World Forum for Harmonization of Vehicle Regulations

Working Party on Pollution and Energy

Regulation No. 83(Emissions of M₁ and N₁ categories of vehicles)**Proposal for draft amendments to Supplement 1 to the
06 series of amendments to Regulation No. 83****Submitted by the expert from the Netherlands ***

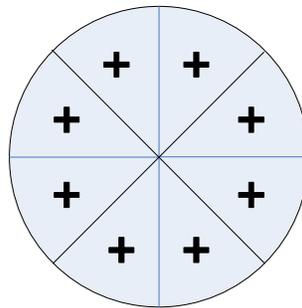
- (a) For blowers with rectangular outlets are located at the centre of each rectangle dividing the whole of the blower outlet into 9 areas (dividing both horizontal and vertical sides of the blower outlet into 3 equal parts). **The centre area shall not be measured (as shown in the diagram below).**

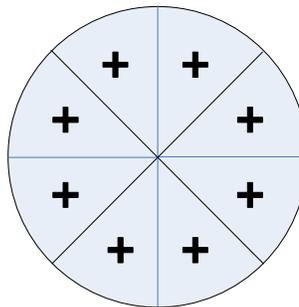
- (a) For blowers with rectangular outlets are located at the centre of each rectangle dividing the whole of the blower outlet into 9 areas (dividing both horizontal and vertical sides of the blower outlet into 3 equal parts). **The centre area shall not be measured (as shown in the diagram below).**
